ADDENDUM NO. 6

New Regional Office for
First Community Bank
HWY. 62/412 AND BIG CREEK ROAD
Jonesboro, AR

Project #1711

February 6, 2023

SITE PLAN

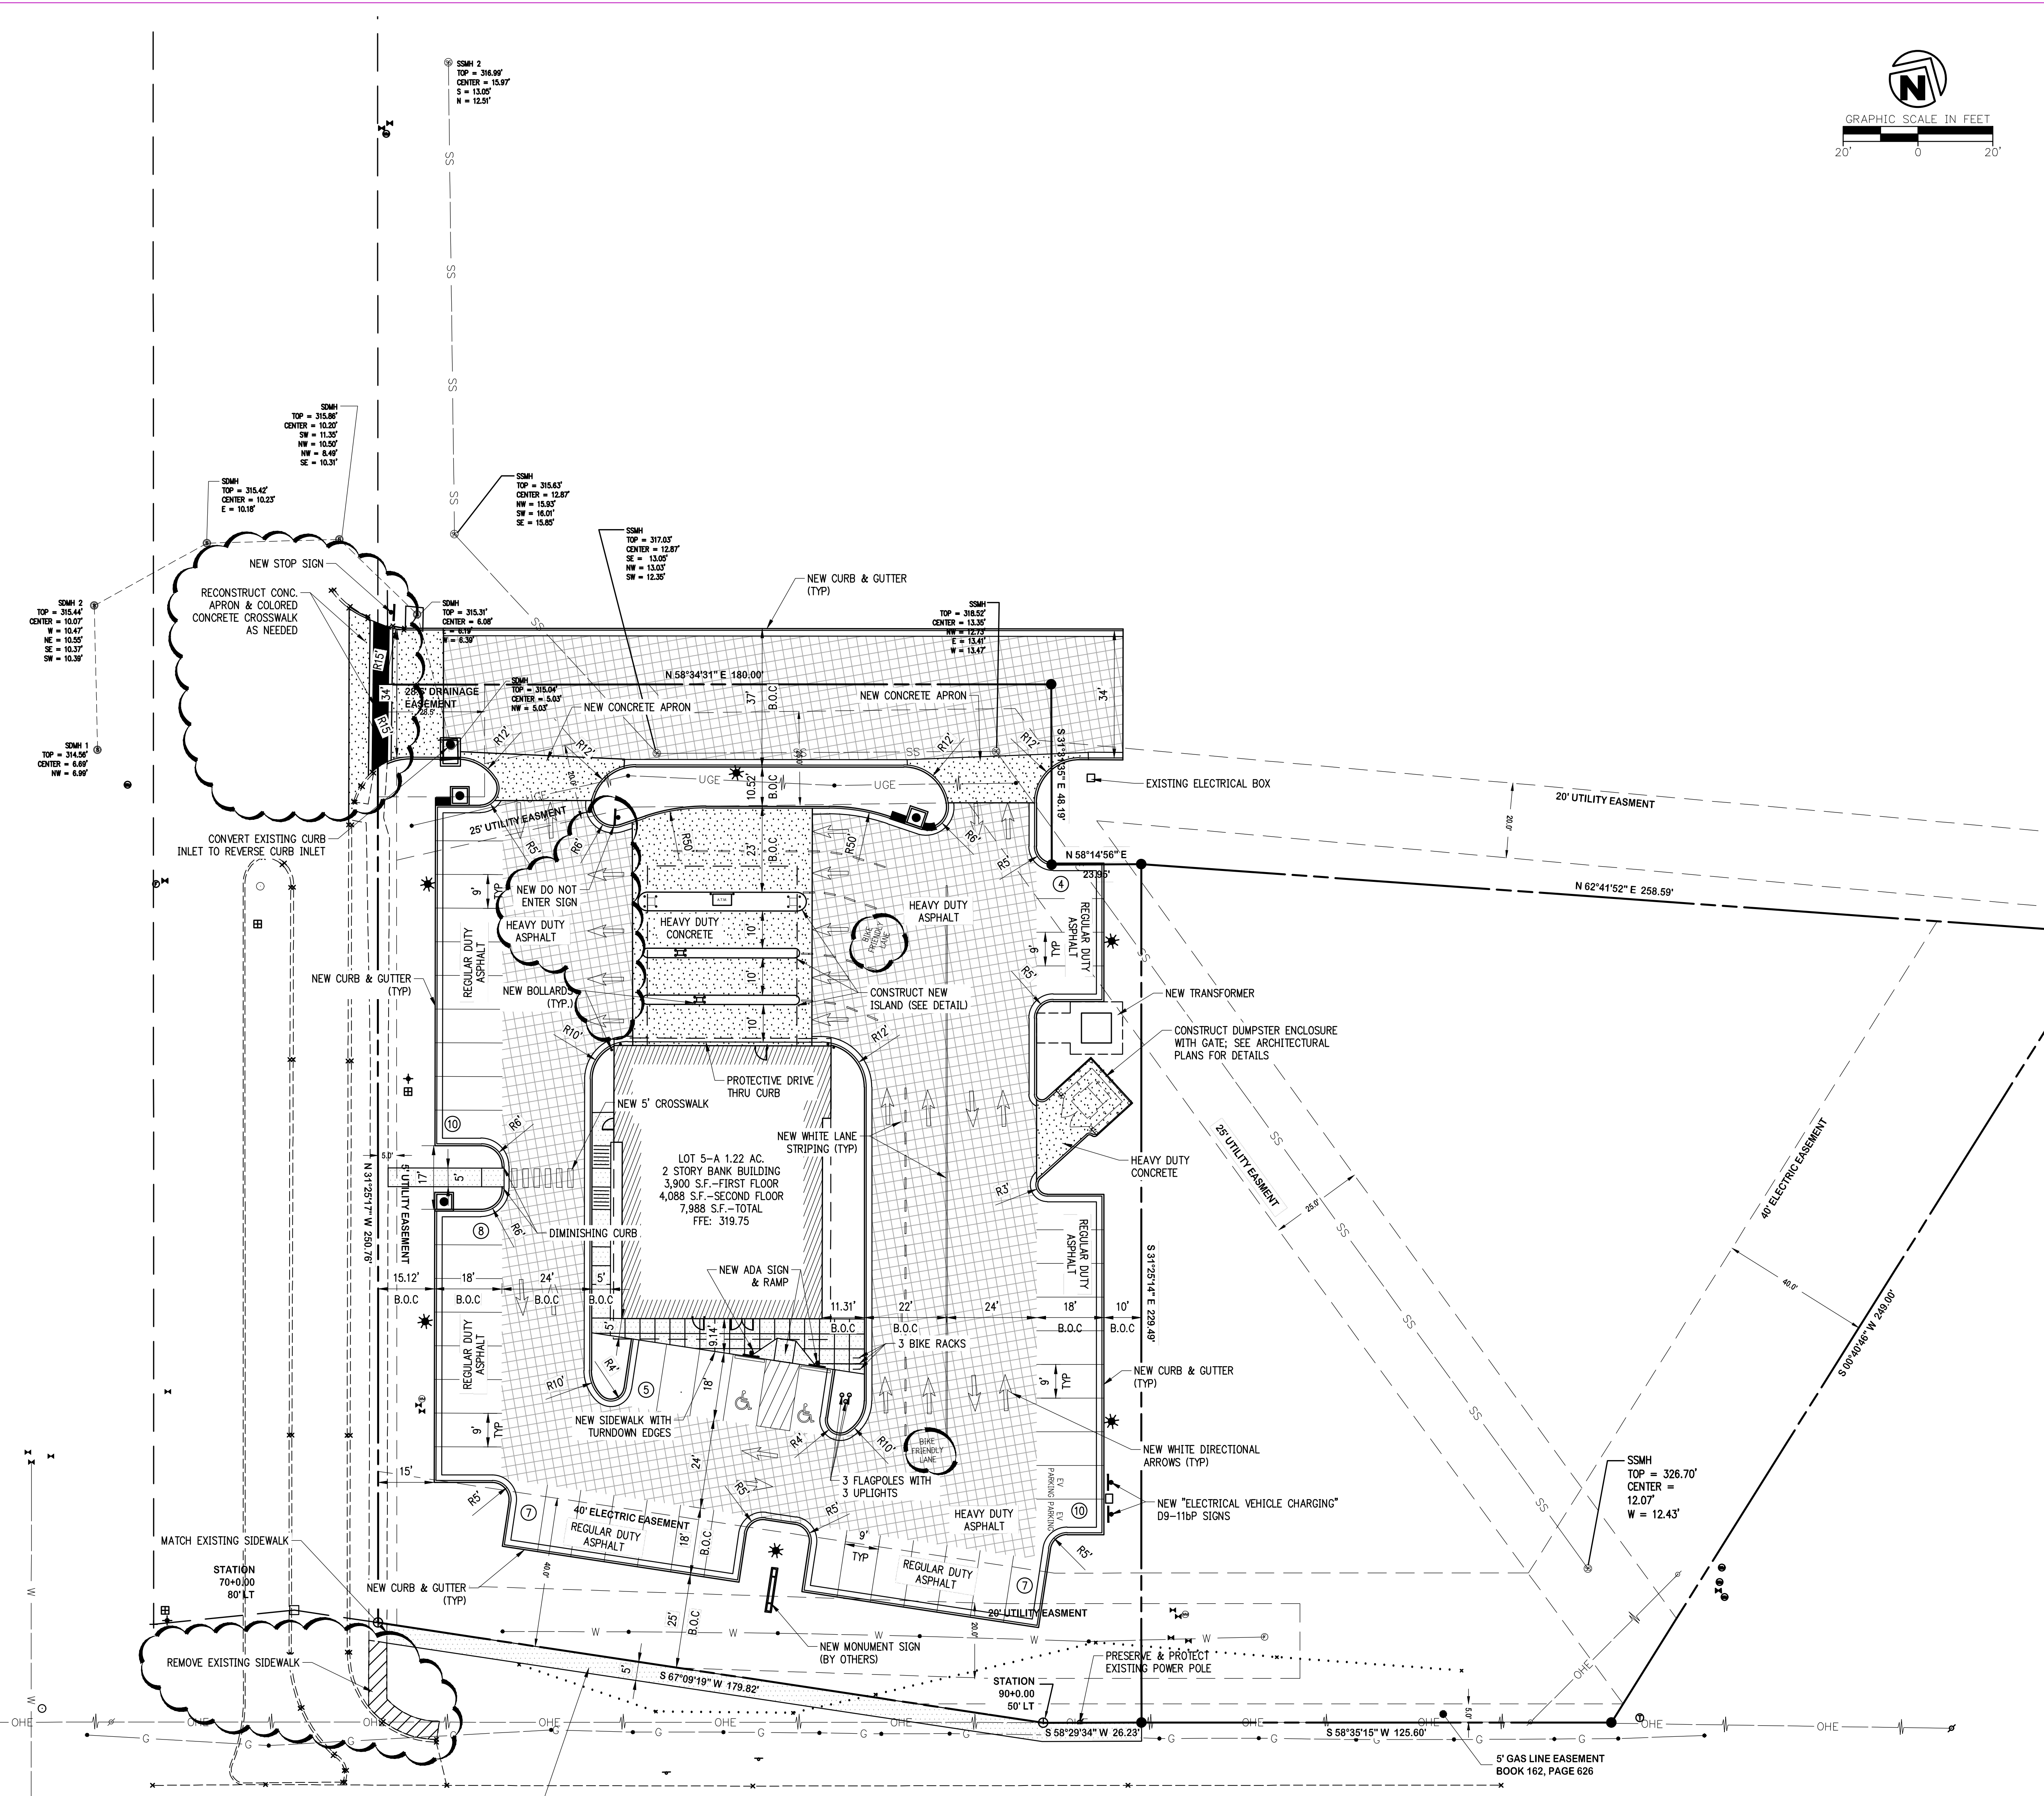
- A. Sheets C1.1 and A1.0: Refer to attached reissued Sheets for the following revisions:
 - 1. Remove existing sidewalk as shown. Add pavement markings and signage as shown. Included in base bid provisions for repairing or replacing the existing concrete apron and colored concrete crosswalk at Chancery Lane.
- B. Sheet A4.3:
 - 1. Refer to detail B/A4.3: All flashing associated with metal wall panels, including the parapet cap, to be by metal panel manufacturer detail B/A4.3 Other flashing to match metal wall panel Champagne color.
